**SUNDRY NOTICES AND REPORTS ON WELLS**

8. Well Name and No.  
**WILLIAMS B FEDERAL #5**

## Proposed San Andres Recompletion

**Williams B Federal 5**  
**30-015-35545**  
**LRE Operating, LLC.**  
**June 11, 2013**  
**Conditions of Approval**

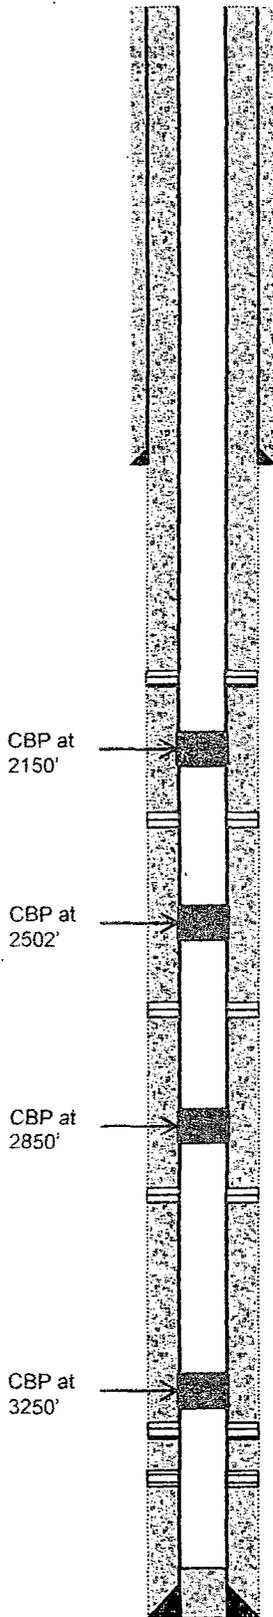
- 1. The operator shall place CBP at 3250' and recomplete as proposed.**
- 2. If operator wishes to DHC an NOI must be submitted.**
- 3. If no DHC is done for the Glorieta-Yeso perforations, an NOI must be submitted to isolate the Glorieta formation according to NMOC regulations. (This can be done before the well is plugged and/or abandoning the San Andres formation.)**
